N141/02 KNX-DALI Gateway Release Notes for firmware version 03 and application program 981C05

Please find the software to upgrade to firmware version 03 at
http://www.buildingtechnologies.siemens.com/BT/GLOBAL/EN/PRODUCTS_SYSTEMS/ET/GAMMA/GAMMA_SUPPORT/Pages/tools.aspx.

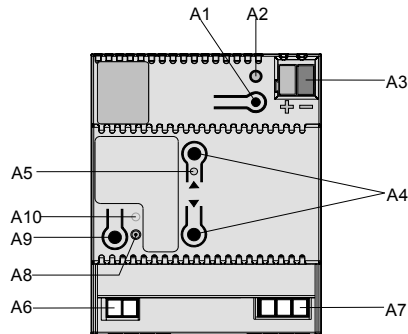
2-level time switch mode without automatically switching off

Starting with firmware version 03 of the N141/02, the 2-level time switch mode for groups and individual luminaires (ballasts) can be configured to not switch off automatically.

This allows for setting a minimum light level for corridors and similar rooms as long as the lighting is not switched off by a wall switch or a central control command.

Parameter	Settings
On period 2 [hh:mm:ss]	00:00:30
hh= for hours; mm= for minutes; ss= for seconds. Here, in 2-level time switch mode, the time is entered that commences after the interim dimming value has been achieved (i.e. according to the dimming value after On period 1 has elapsed). When this time elapses the ballast is switched off. On period 2 is a maximum of 15 hours (15:00:00). When On period 2 is set to 00:00:00 then the time for the interim dimming value does not automatically elapse, i.e. the ballast is not automatically switched off. The diagram does not reflect this setting.
